Post Drilling/Annual Well Site Inspection Form

| Section 1: General Information | |
|--|---|
| Operator Name Snake River Oil + Gas, LLC | Inspector Name James Thum |
| Well Name Kauffman #1-34, USWN 11-075-20024 | Area Office Boise / Director's |

Well pad from lease entrance, looking NW. Note vegetation in vicinity of well head.

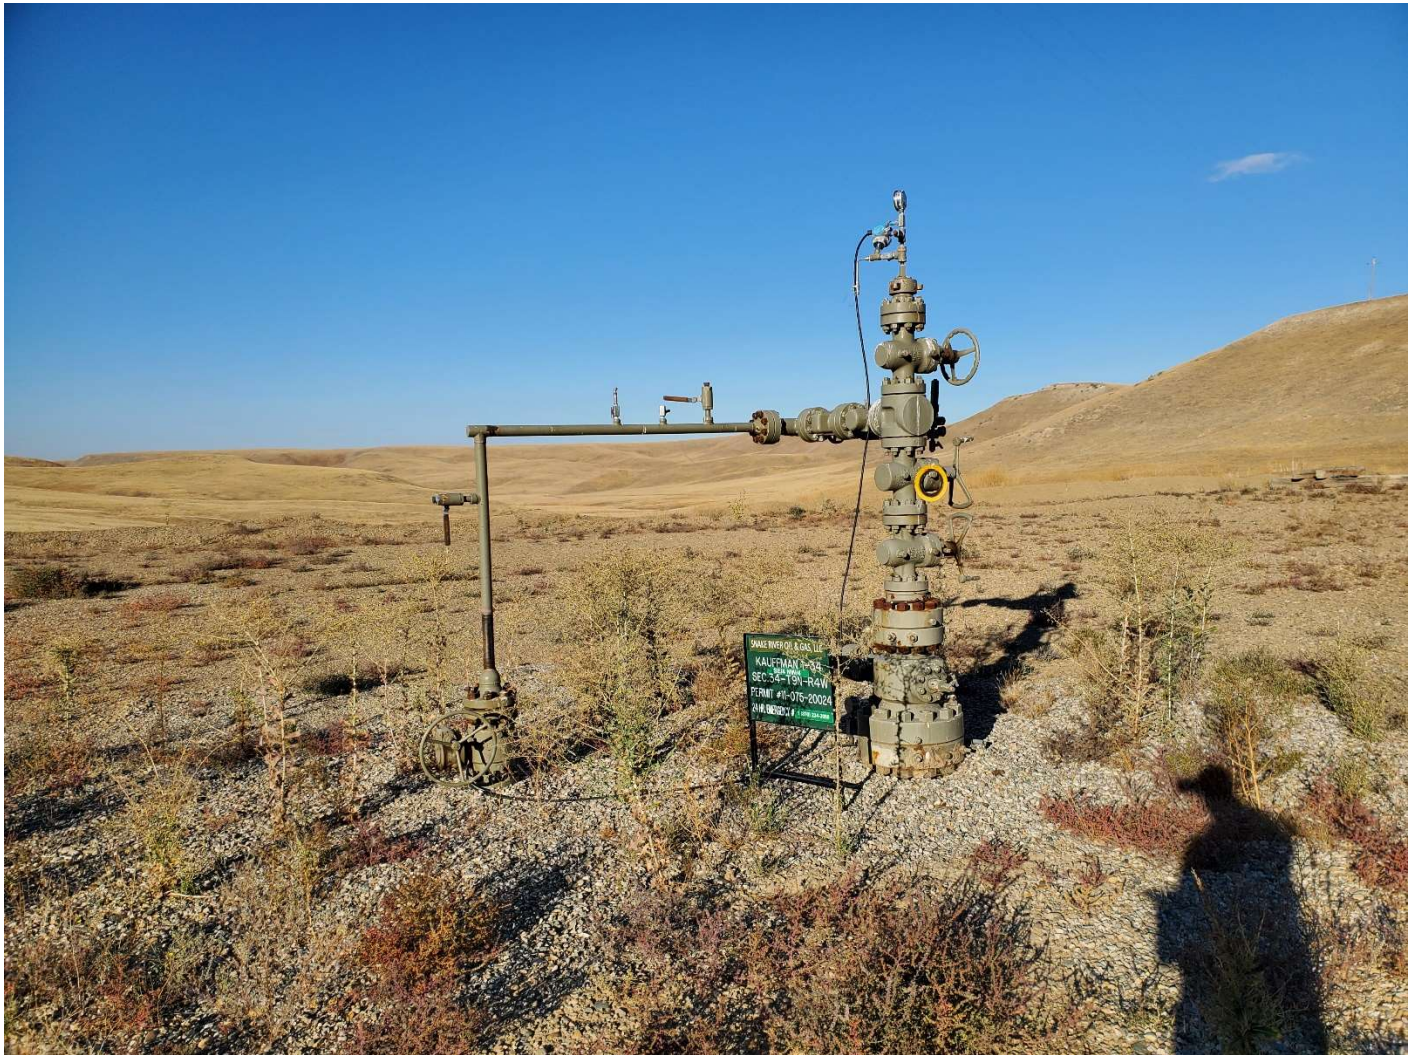
Pad and fencing in need of weed remediation with vegetative covering >15% of the well pad, notably in the vicinity of the well head and south part of pad. Vegetation shows a marked increase from the 2021 inspection.
